Change Order

PROJECT: (Name and address)
Illini Central Addition and Renovation
208 Northwest Avenue
Mason City, IL 62664

Change Order Number: 014

RFP 37: Toilets / Ramp - ADD \$216,328

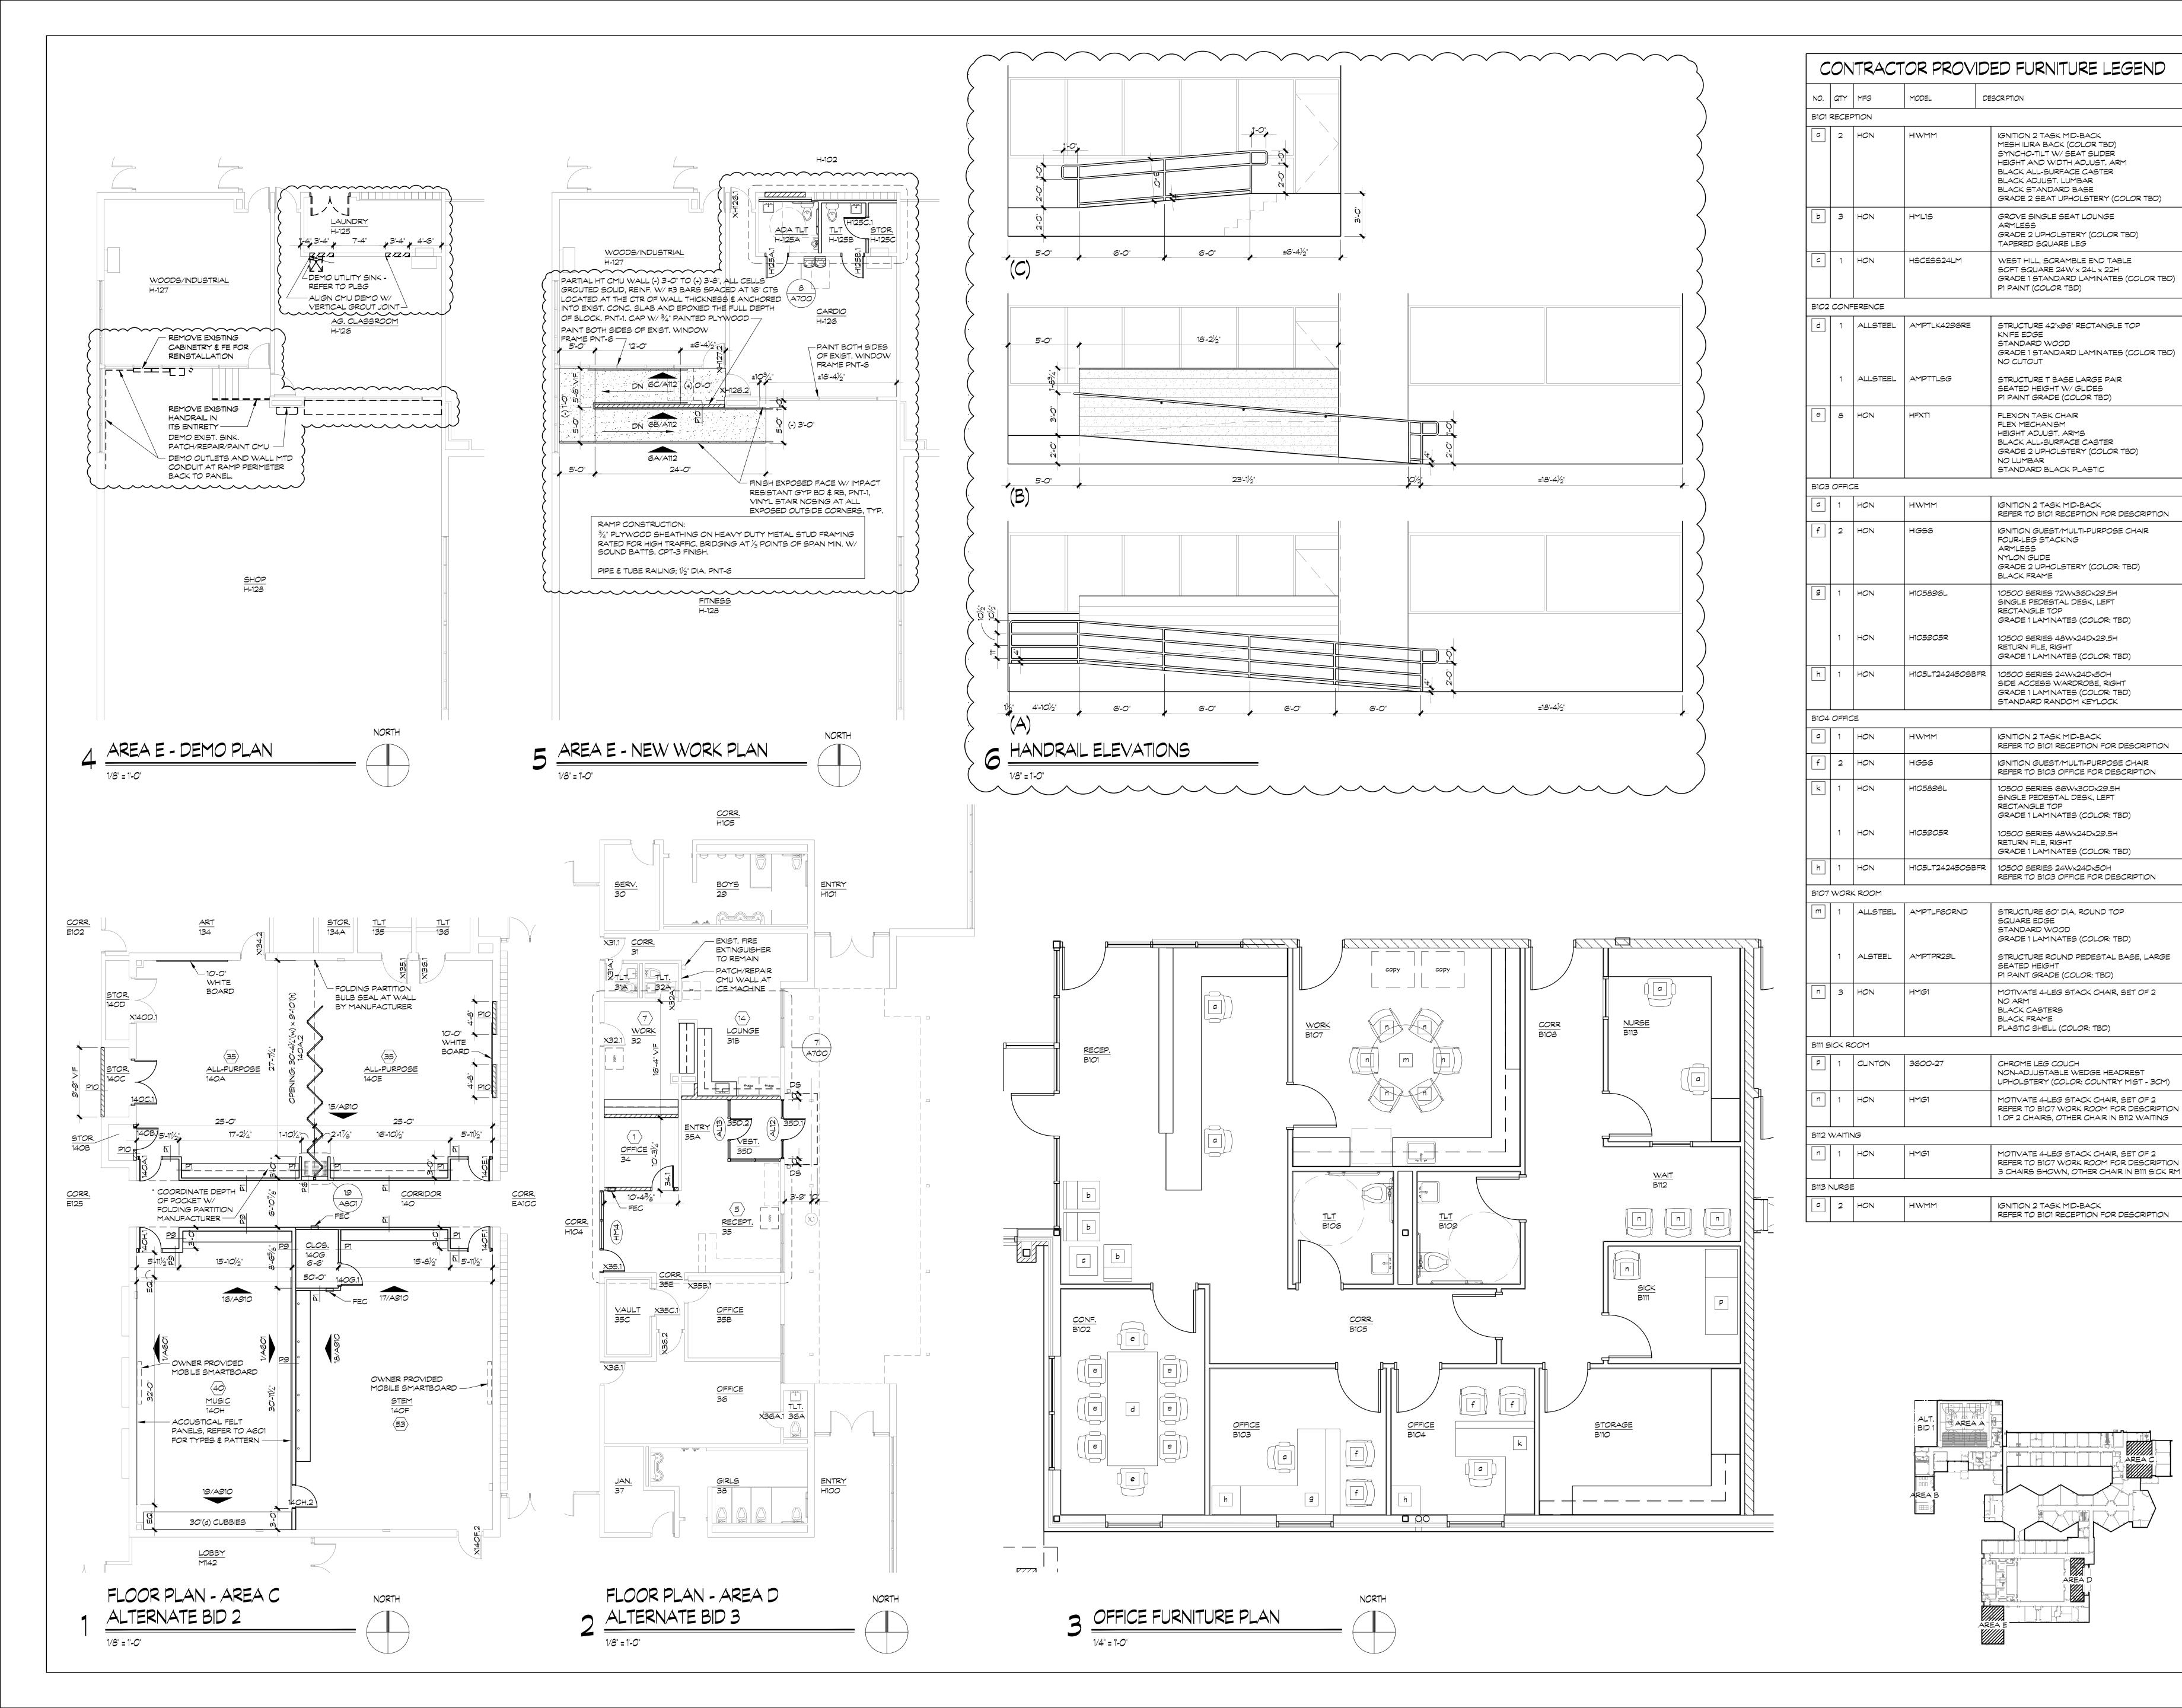
Demo and renovate existing Laundry Room into two single-user toilet rooms and one storage room. All associated MEP and architectural finishes to be included per attached drawings. Asbestos abatement will be done under a separate contract.

Also, include building an ADA ramp into the previous shop area from the previous Ag Classroom per attached drawings.

FLOOR PLAN - AREA E - PLUMBING

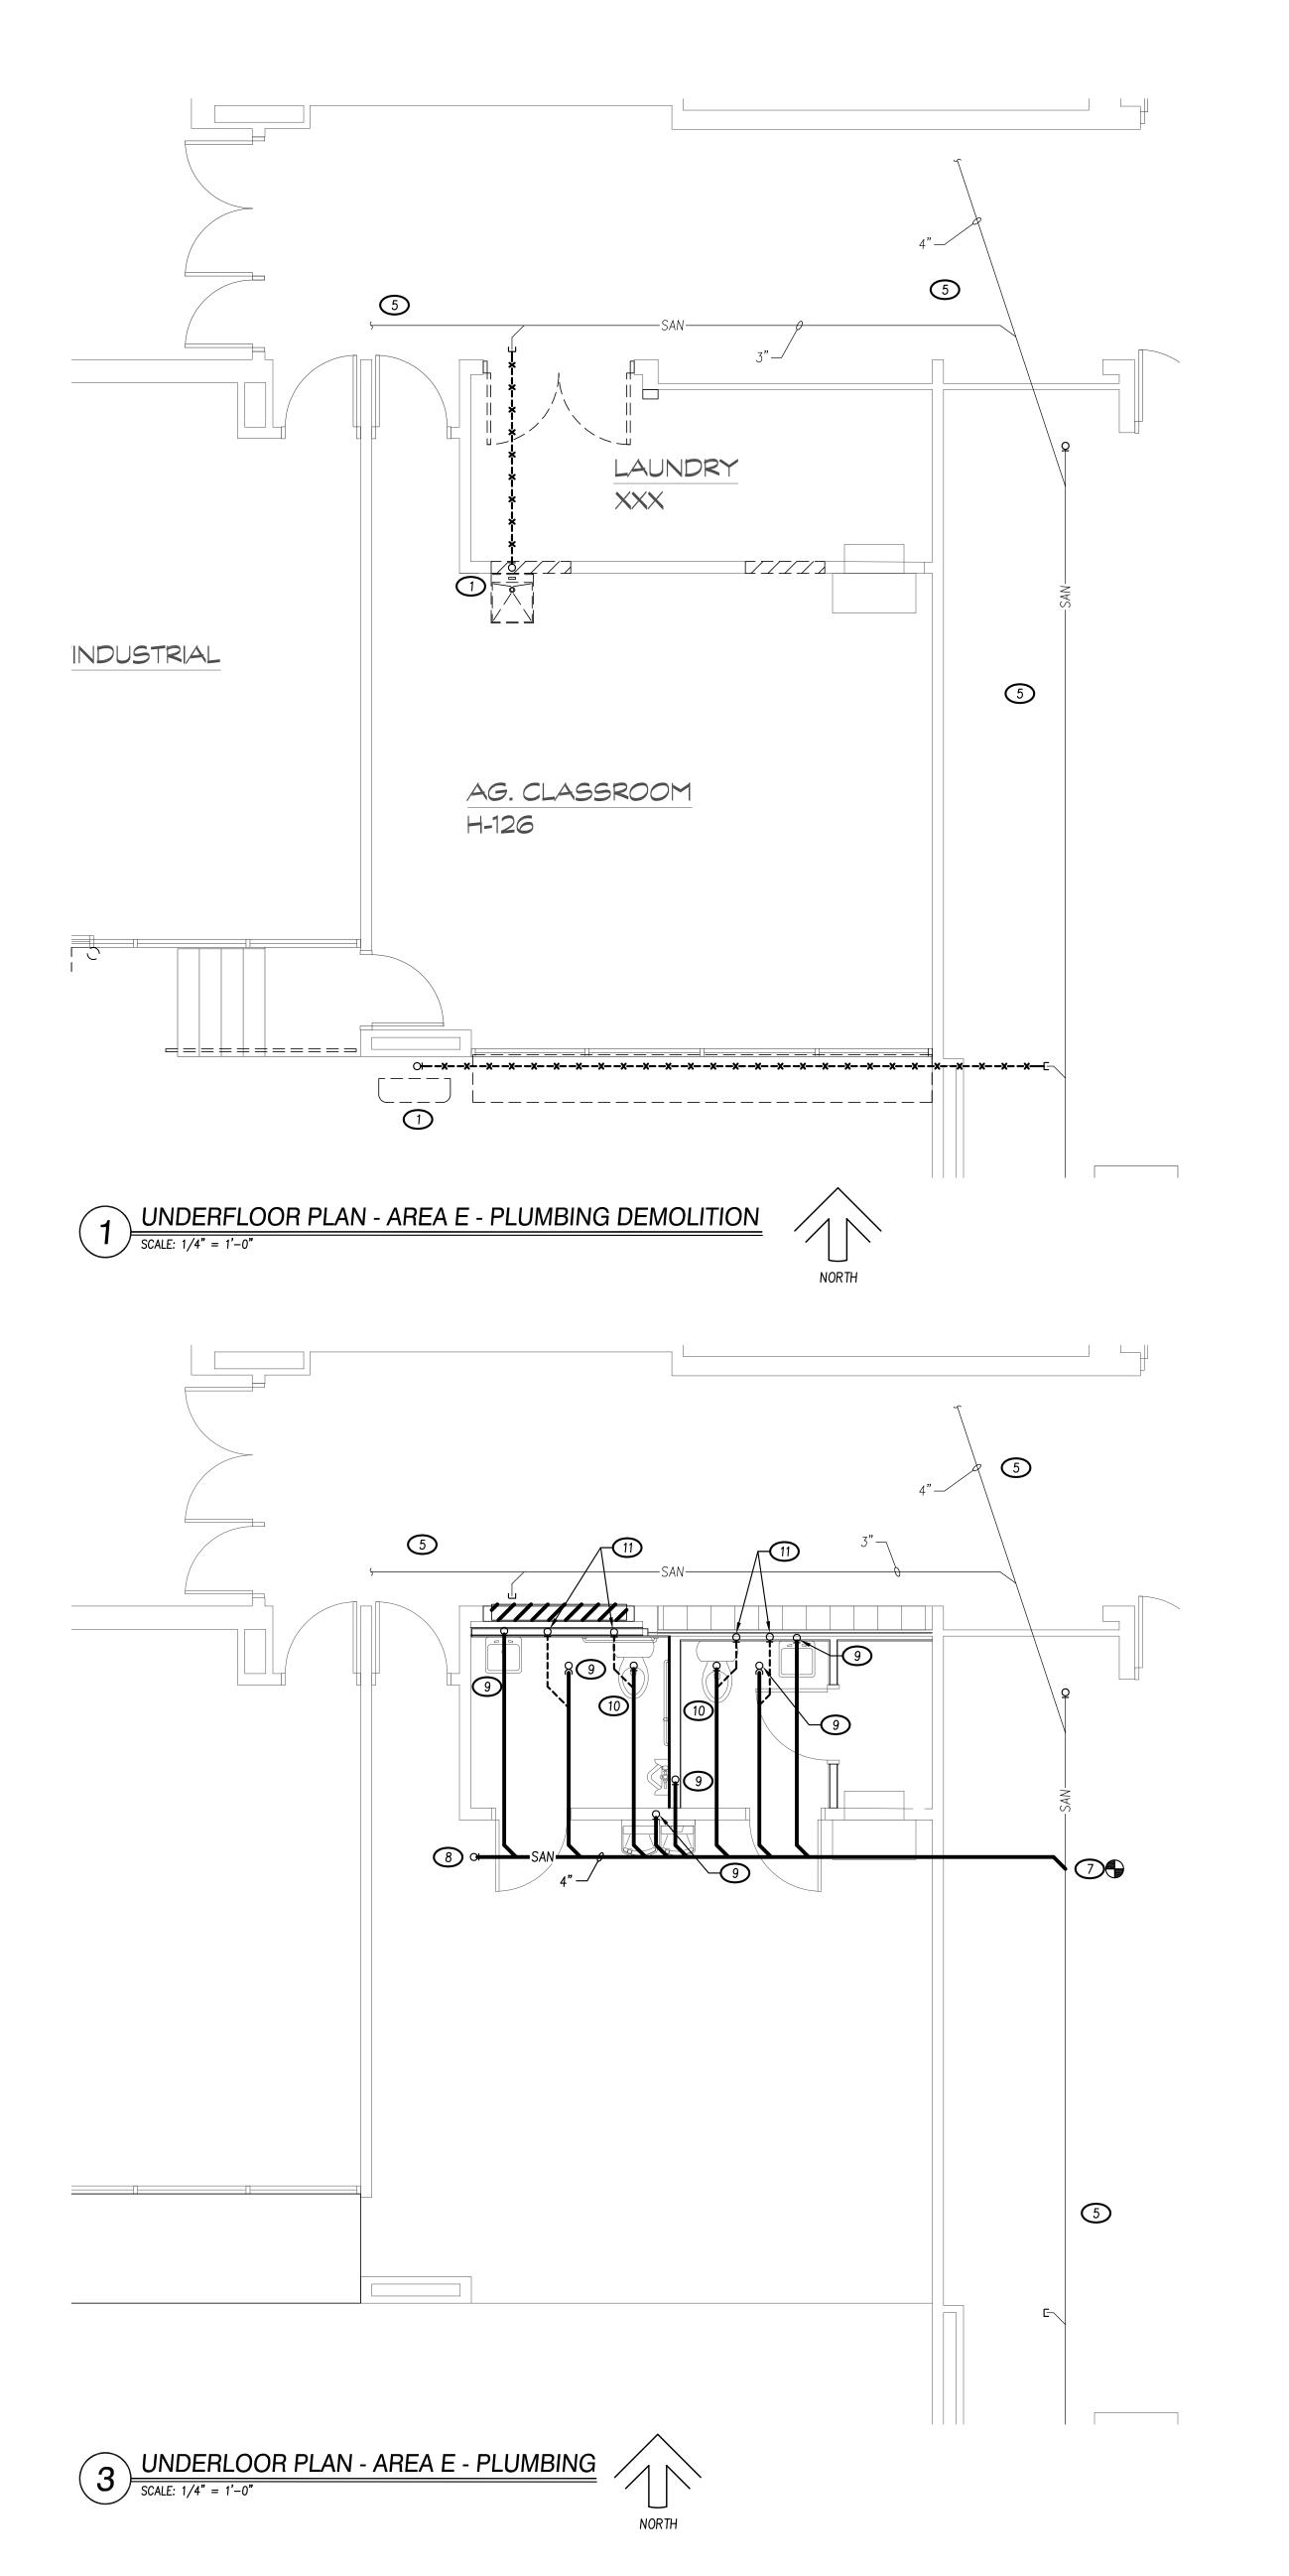
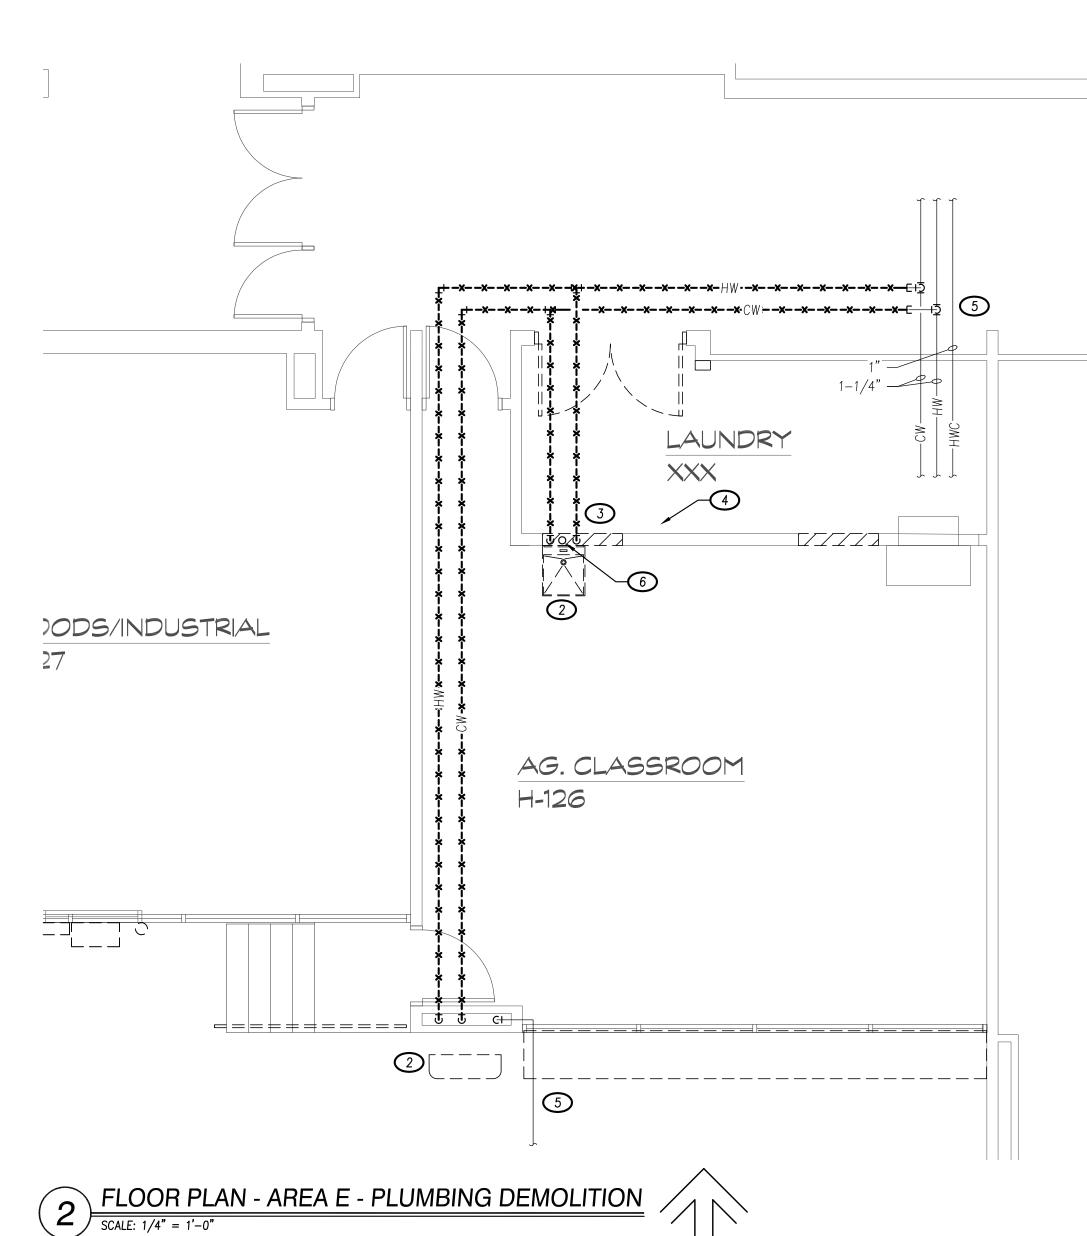
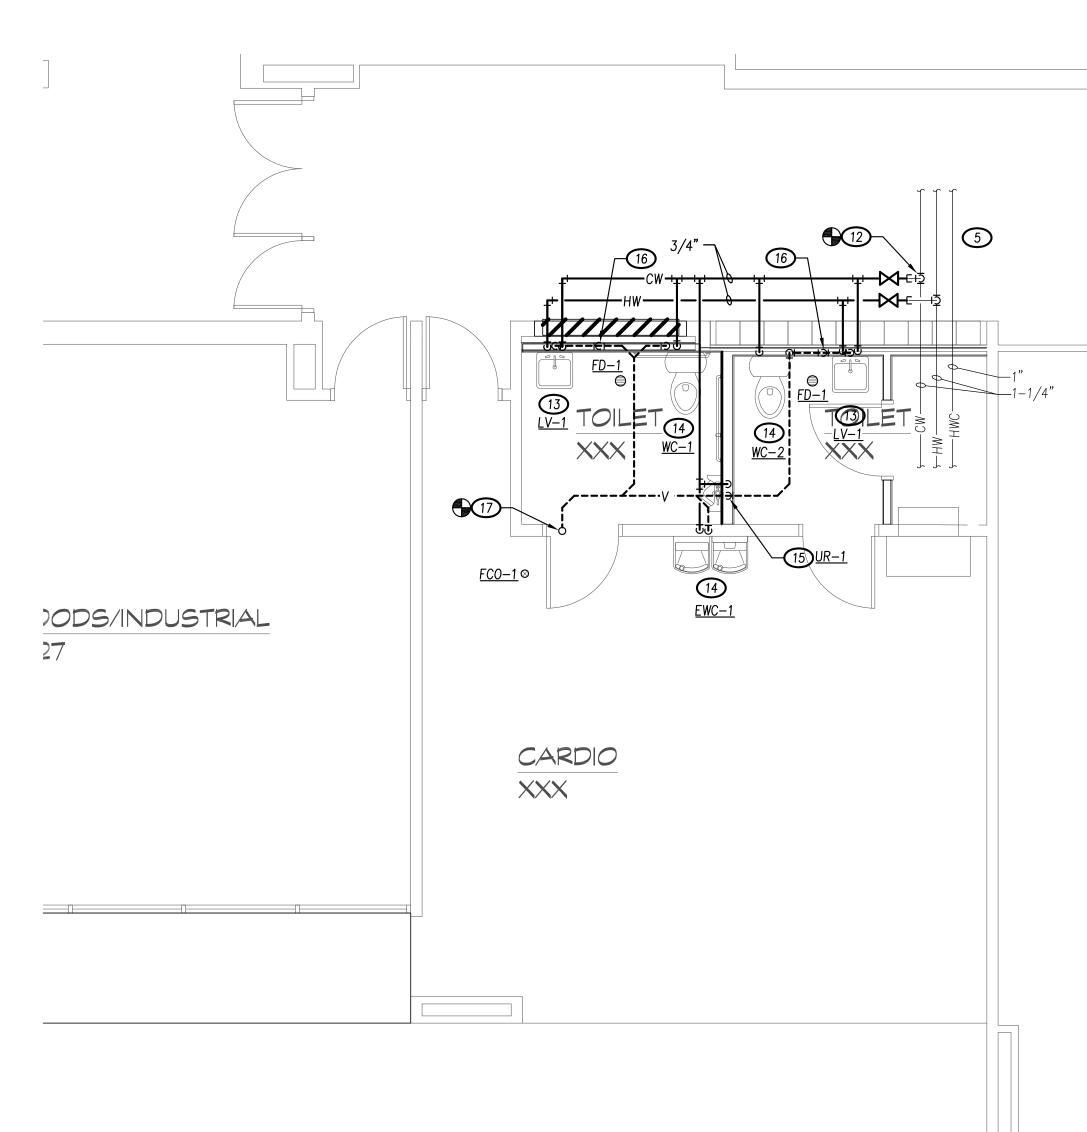
- 1 REMOVE EXISTING 3" WASTE PIPING FROM ABOVE, BACK TO MAIN AND CAP.
- 2 REMOVE EXISTING SINK AND ASSOCIATED SUPPLY, WASTE AND VENT PIPING, BACK TO MAIN AND CAP.

- REMOVE EXISTING WASHER BOX AND ASSOCIATED SUPPLY, WASTE AND VENT PIPING, BACK TO MAIN AND CAP.
- REMOVE EXISTING GAS PIPING FROM DRYER IN THIS APPROXIMATE LOCATION, BACK TO MAIN AND CAP.

- 5 EXISTING PIPING TO REMAIN.
- 6 EXISTING 3" VENT THROUGH ROOF TO REMAIN.
- CONNECT NEW 4" WASTE PIPING TO EXISTING WASTE PIPING IN THIS APPROXIMATE LOCATION.

- 8 4" WASTE TO CLEANOUT ABOVE.
- 9 2" WASTE FROM ABOVE.
- 10 4" WASTE FROM ABOVE.
- 11) 2" VENT UP.
- CONNECT NEW 3/4" CW PIPING AND 1/2" H2 PIPING TO EXISTING PIPING IN THIS APPROXIMATE LOCATION.

- 1/2" H&CW DOWN. 2" VENT FROM BELOW.
- 14 1/2" CW DOWN. 2" VENT FROM BELOW.
- 15) 3/4" CW DOWN. 2" VENT FROM BELOW.
- 16) 2" VENT FROM BELOW.
- (17) CONNECT NEW 2" VENT PIPING TO EXISTING 3" VENT THROUGH ROOF.
